HISTORIC PRESERVATION COMMISSION

Monday, March 2nd, 2026

**City of Avondale Estates
Historic Preservation Commission
COA Application Review***

City of Avondale Estates
Historic Preservation Commission
COA Application Review*

Design photos for proposed windows (exact same specs as windows replaced elsewhere in house)

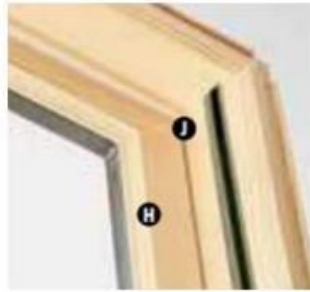
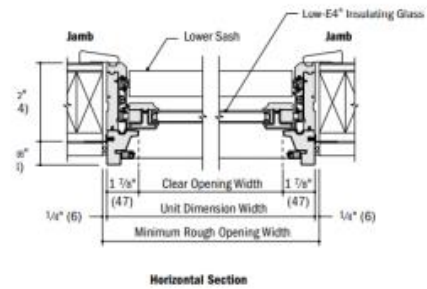
The porch's 4-over-4, double-hung wood windows are not original but may be considered historic elements. Replacement windows should be wood as proposed. The use of 4-over-4 sash instead of 6-over-1 should be considered to help maintain the porch's historic appearance.

- New enclosure materials on the porch should be wood rather than a synthetic material such as fiber-cement.
- Respect the porch's existing historic elements by using panels with a similar appearance to the beaded board panels and by considering the use of 4-over-4, double-hung, wood windows rather than 6-over-1.
- New rear entrance and basement doors should be wood rather than a synthetic material such as fiberglass.

Deck

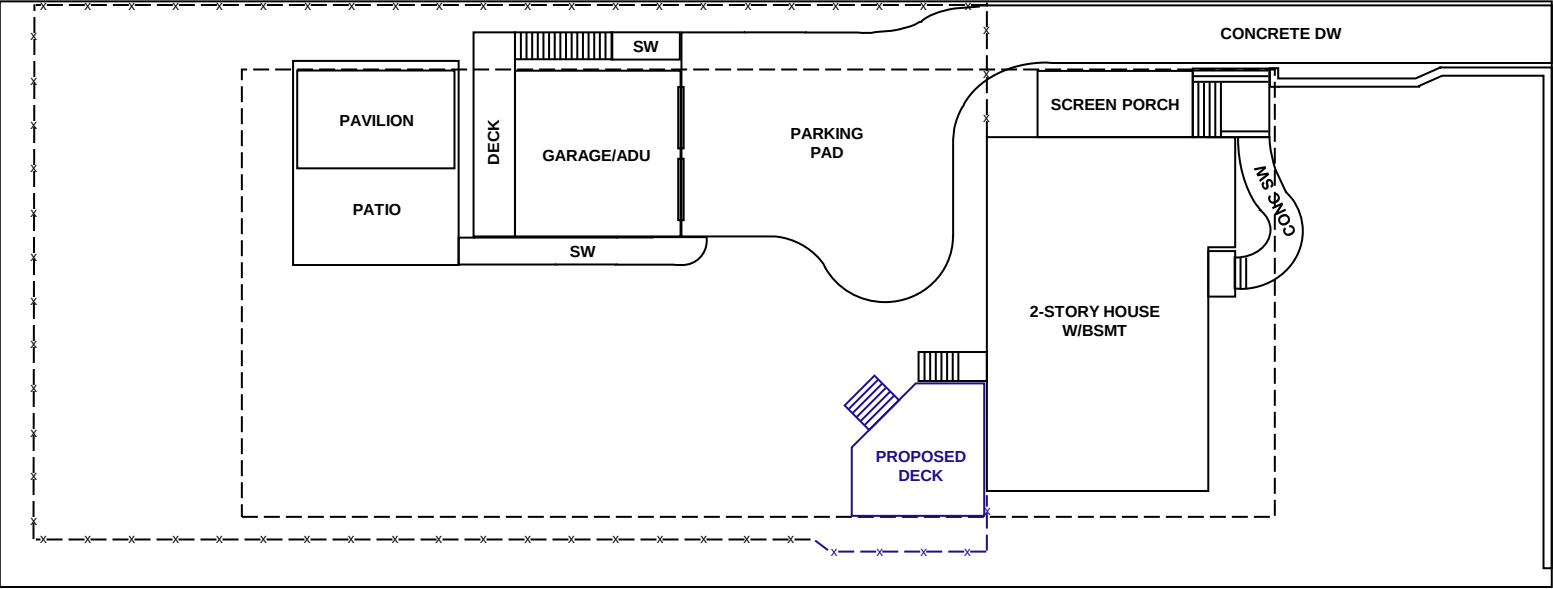
The addition of a new deck is allowed on the house's rear elevation (see *Guidelines for Materials* below). Removal of the masonry steps is also allowed due to their location at the rear elevation. The additional 400 SF of the new deck minus the rear steps and concrete landing brings the total lot coverage to 34.6%.

Since the porch is an original part of the house and its existing features may be considered historic elements, finish materials such as synthetic fiber-cement siding and fiberglass doors are not allowed on this original portion of the house. Replacement materials should be wood to match the existing historic materials. The use of composite materials for the new deck is acceptable because the deck is a new addition to the original house and is on the house's rear elevation.
